Access Compliance Report Public Rights-of-Way (Curb Ramps)

Main Street: CALLIANDRA_ST Cross Street: SNOW_BUSH_ST Location: S

ADA ID: RPRK211028135541 Ramp Type: Type 4 - Parallel Initial Pass/Fail: Pass Overall Compliance: No Severity Score: 25

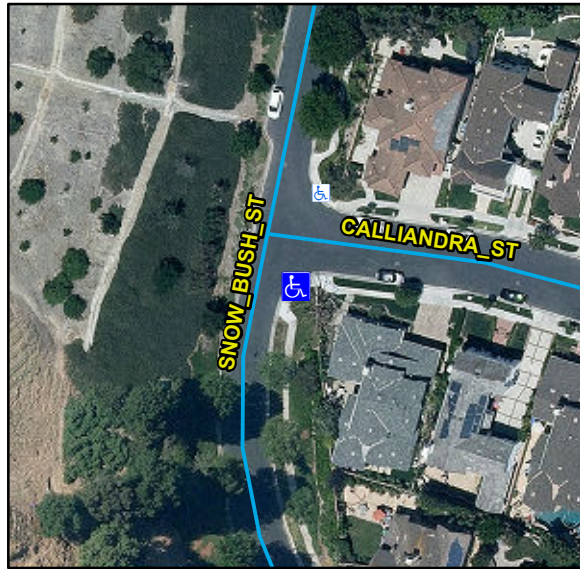
Compliance	Description	Data	Compliance	Description	Data
N/A	Ramp Length LT (in)	129	N/A	Ramp Length RT (in)	127
Yes	Ramp Width LT (in)	54	Yes	Ramp Width RT (in)	54
Yes	Ramp Run Slope LT (%)	3.1	Yes	Ramp Run Slope RT (%)	5.2
Yes	Ramp Cross Slope LT (%)	1.2	Yes	Ramp Cross Slope RT (%)	0.4
N/A	Landing Present	No	No	DWS Provided	No
N/A	Landing Length (in)	N/A	N/A	DWS Contrast	N/A
No	Landing Width (in)	N/A	N/A	DWS Length (in)	N/A
No	Landing Run Slope (%)	N/A	N/A	DWS Full Width	N/A
No	Landing Cross Slope (%)	N/A		DWS Offset Type	N/A
N/A	Landing Movement Obstructed?	No	N/A	DWS Offset Left (in)	N/A
	Landing Movement Type	Curb	N/A	DWS Offset Right (in)	N/A
N/A	Landing Shared	N/A			
N/A	Clear Space	Yes			
N/A	Clear Space To Crosswalk (in)	48			
N/A	Marked Crosswalk 1	No	N/A	Marked Crosswalk 2	No
	Crossing 1 Direction	NE		Crossing 2 Direction	NW
N/A	Marked Crosswalk 1 Width (in)	N/A		Marked Crosswalk 2 Width (in)	N/A

N/A	Ramp Inside Crosswalk 1	N/A	N/A	Ramp Inside Crosswalk 2	N/A
	Crossing 1 Slope (%)	3.3		Crossing 2 Slope (%)	2.2
	Crossing 1 Cross Slope (%)	3.4		Crossing 2 Cross Slope (%)	1.2
Yes	Gutter Ponding	No	No	Curb Slope	9.9
Yes	Gutter Lip Height (in)	0		Road Run Slope (%)	0.8
No	Gutter Run Slope (%)	10.4		Road Cross Slope (%)	4.6
Yes	Gutter Cross Slope (%)	0.9	No	Perpendicular Joint Present	No
Yes	Overall Surface Condition	Acceptable			
	Cross Gutter Present?	No		Spandrel Present?	No
	Replace Cross Gutter?	N/A		Replace Spandrel?	N/A

Remove & Replace Curb Ramp With Two New Directional Ramps or Equivalent. Remove & Replace Gutter.
